**Proof of Evidence relating to Flood Risk and  
Drainage Matters**

**Save Fulbourn Fields and Fulbourn Forum  
Rule 6 party**

**PINS Reference: APP/W0530/W/22/3291523**

**LPA Reference: S/3290/19/RM**

M:\B411 Fulbourn\_CAMBS\DRAWINGS\AUTOCAD\CURRENT DRGS\B411 - PL - SK - 304 - P02 - TYPICAL SECTIONS

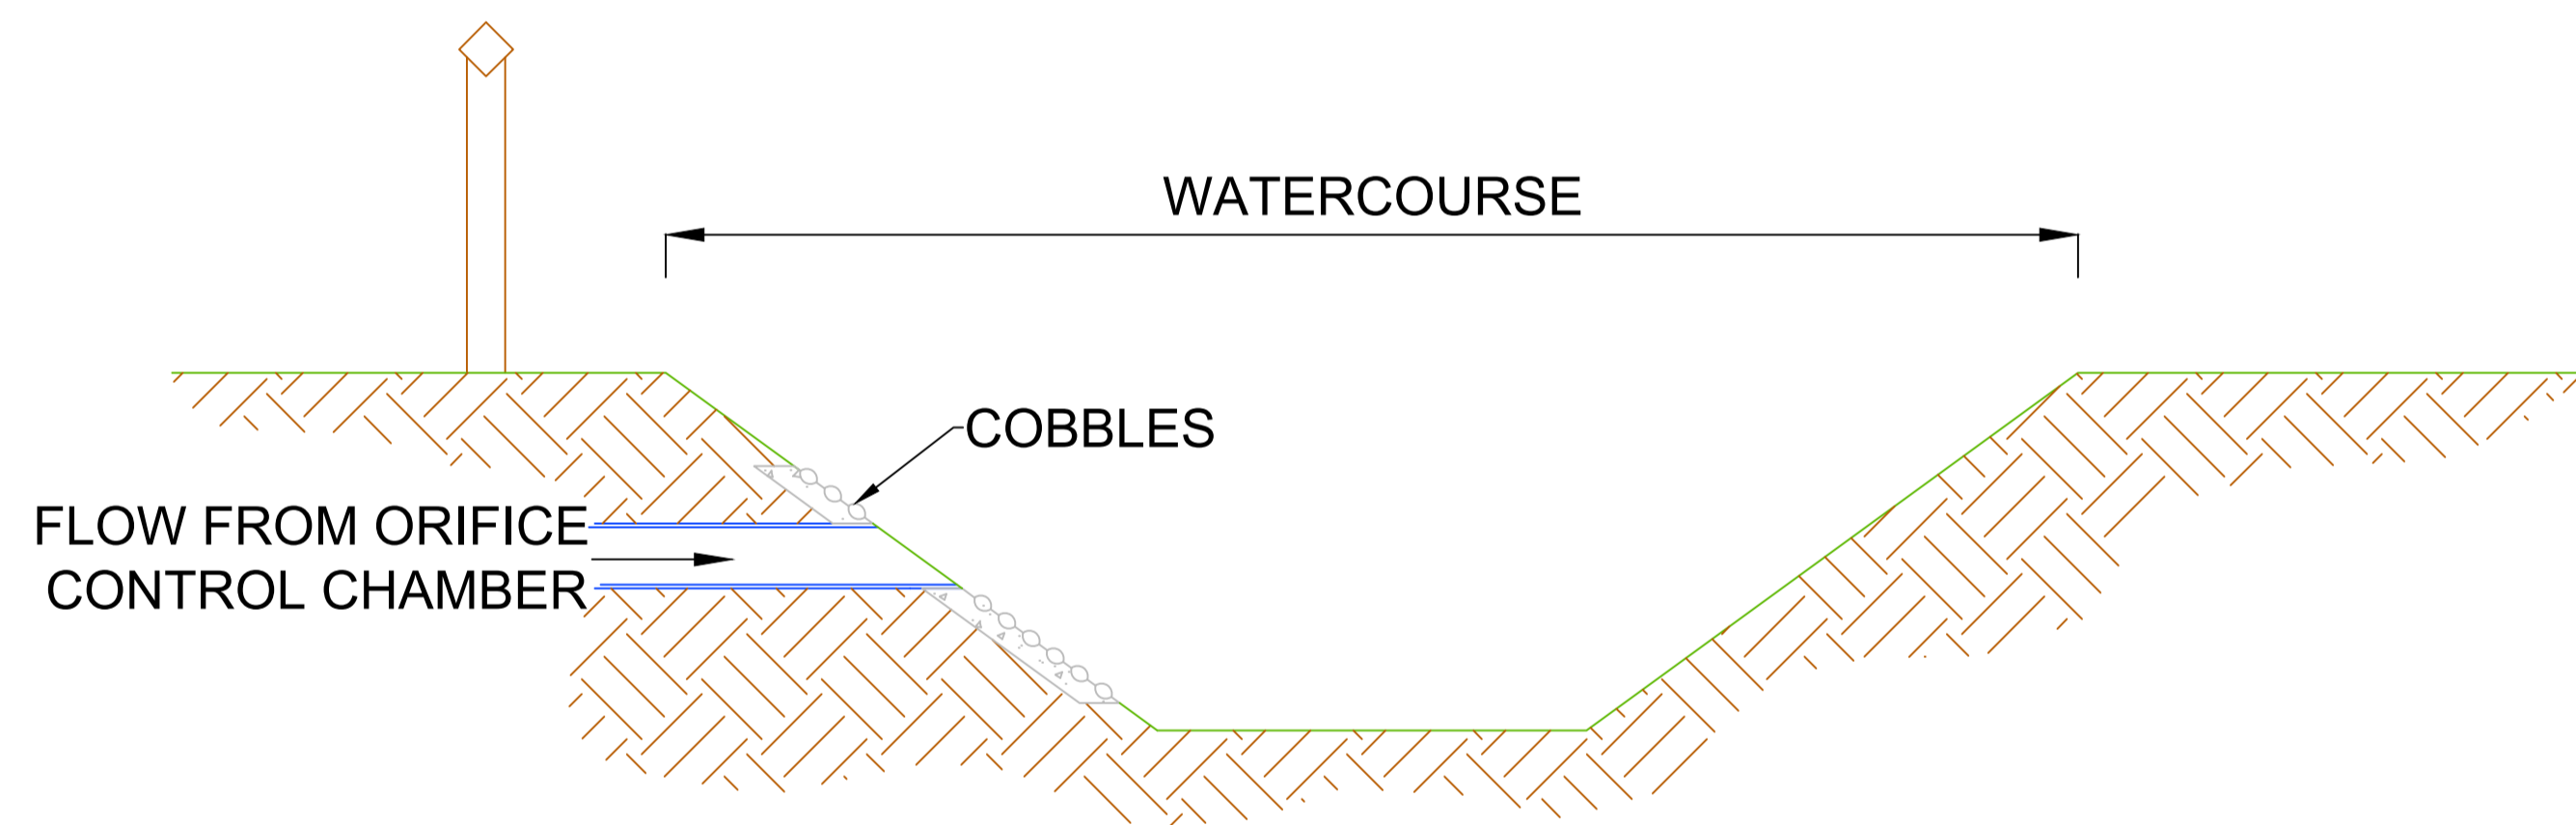
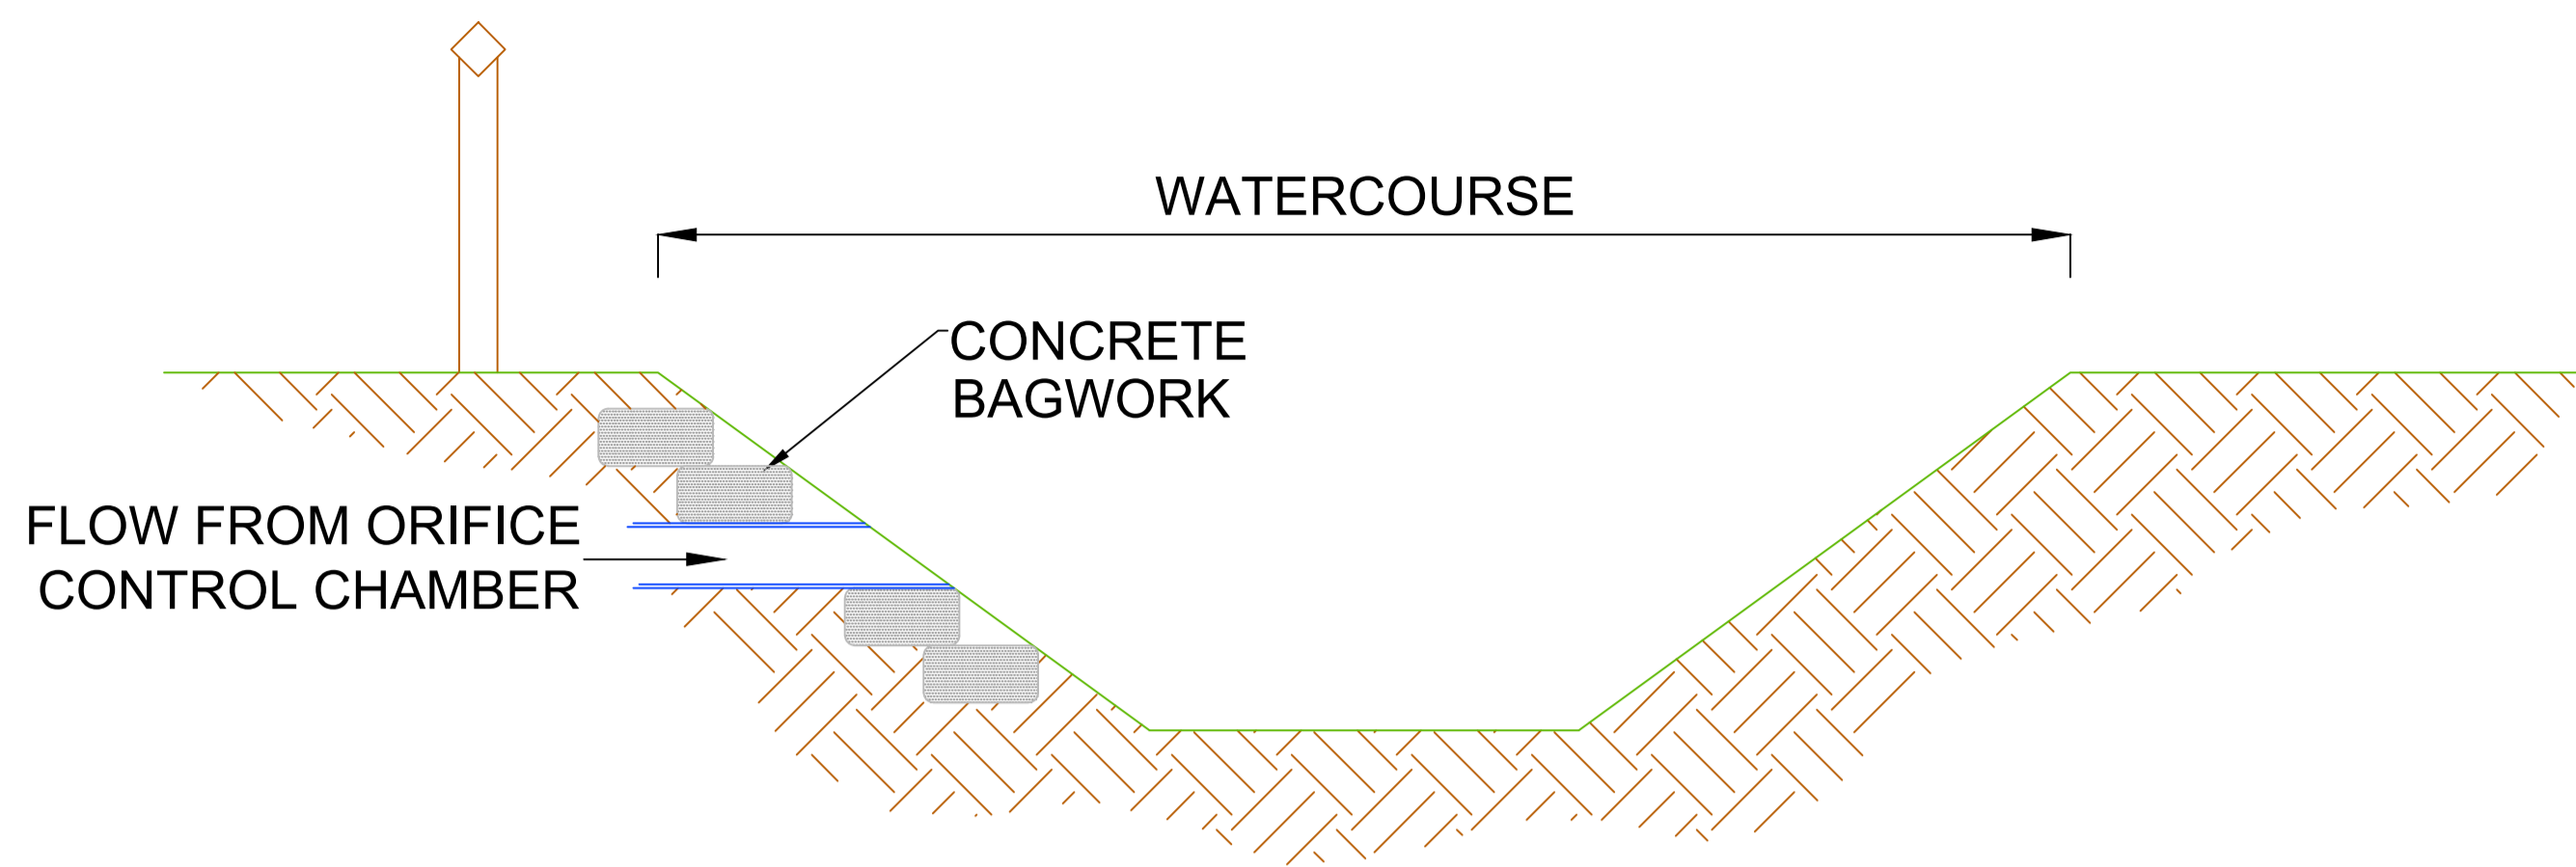
- Permeable paving is shown across the site. The construction details as presented in **Appendix 4** (see Cannon Consulting drawing B411-PL-SK-304 Rev P02) do not include any dimensions or

depths. In our experience a typical detail for permeable paving as proposed would have a depth of 0.79m as shown on the example in **Appendix 8**. Based on the recorded groundwater levels permeable paving would fail and would be subject to flooding unless all roads are raised which we assume will be the case, albeit limited road levels are provided and no updated levels are presented in the 2022 reports.

- The typical construction details as presented in **Appendix 4** show permeable paving discharging into a cellular storage tank which is wrapped in a geotextile to prevent groundwater ingress. The permeable paving is shown to discharge directly into the storage tank, however this cannot be achieved due to the presence of the geotextile which would prevent permeability. The same is also shown for the basin over crates. These details are flawed and would ultimately render the storage ineffective.

Drawing B411 – PL – SK – 321 – Cow Lane Flood Basin

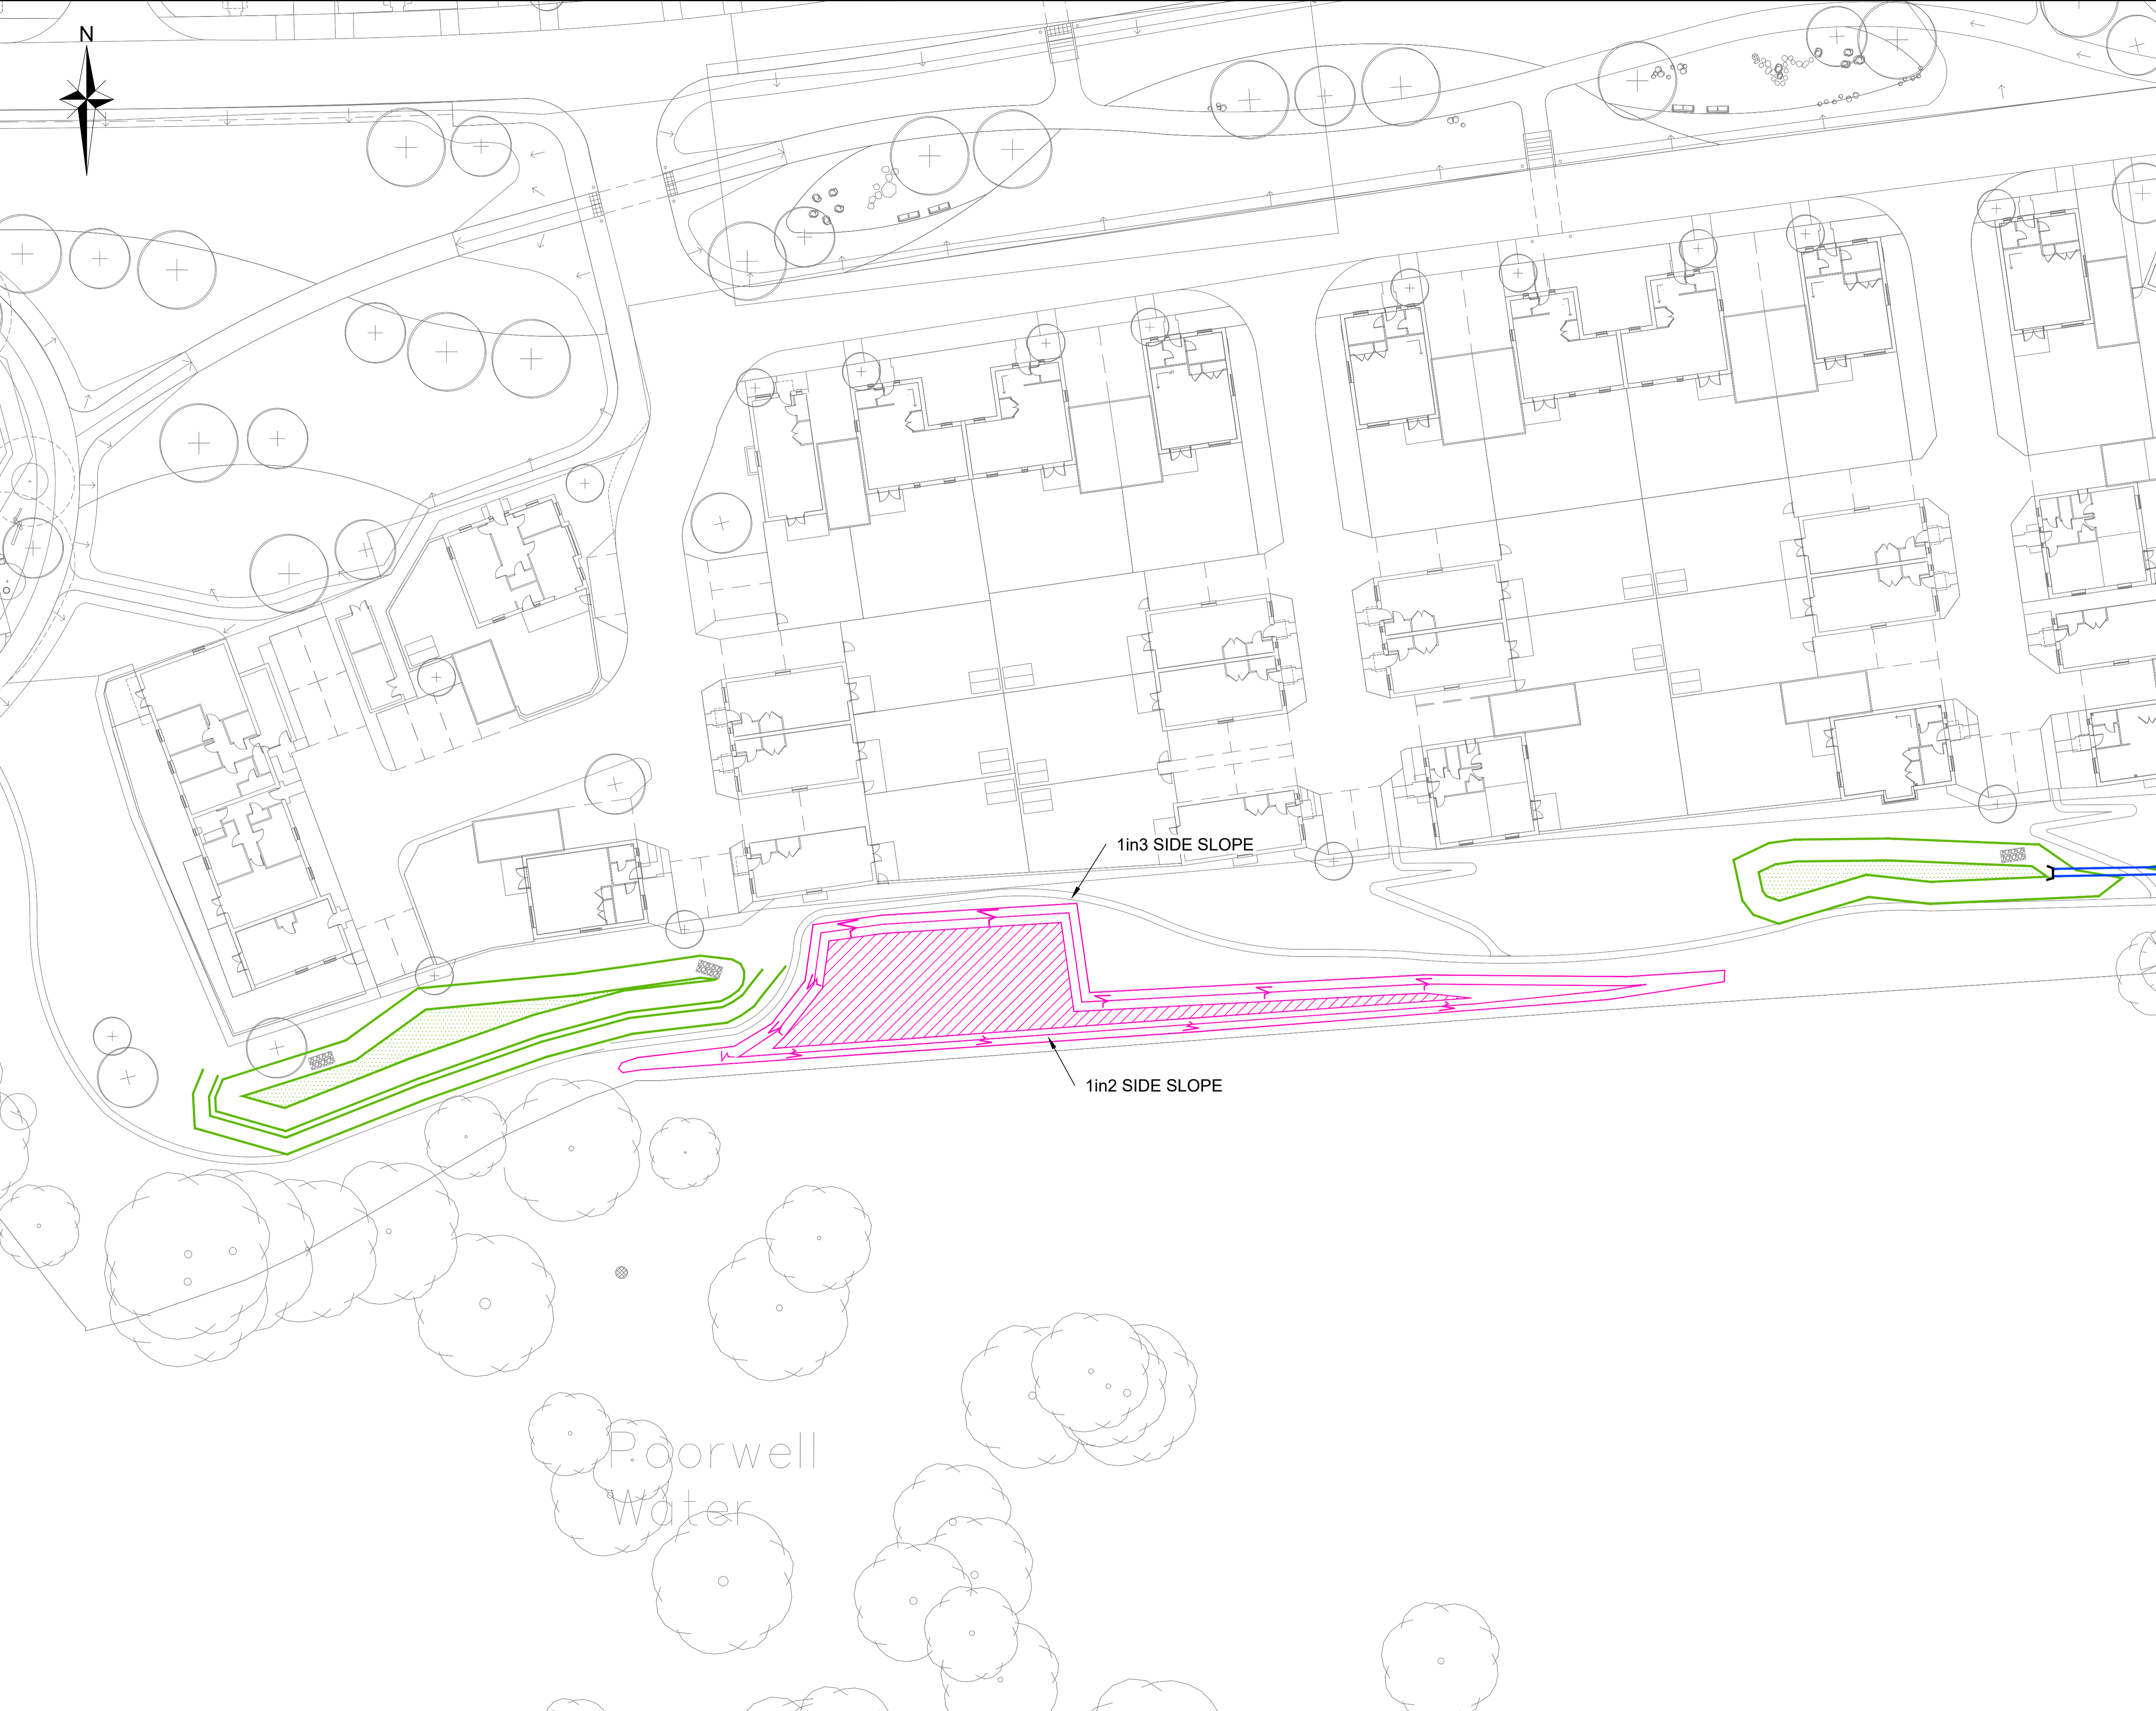
- Along the southern boundary, within the eastern part of the site, a group of levels remain which we assume represents the Cow Lane Flood Basin and so we assume this is consistent to the plan included at **CDG8** and is included as mitigation in the model. The basin appears to extend up to a height of 9.9m on the southern boundary (based on an excavation depth of 9.4m and the basin being 500mm deep). No updated design for this basin is presented in any recent submissions.

- 4.38 This flooding occurs despite continued comments from the Appellant and the results present at **CDG10** where the predicted flood level increases are shown to stop on the site boundary. It is noted whilst the Cow Lane Flood Basin appears to remain based on the Post Development Ground Levels and Platform Extents Plan, the maximum height of the basin (based on the poor information available) is 9.9m, however the maximum flood height is 9.97m in that location so the basin will overtop.

- Proposed flood mitigation measures have not been designed holistically with the wider site layout and drainage proposals. Updated plans do not show the Cow Lane Flood Basin and several proposed culverts do not feature in any designs.
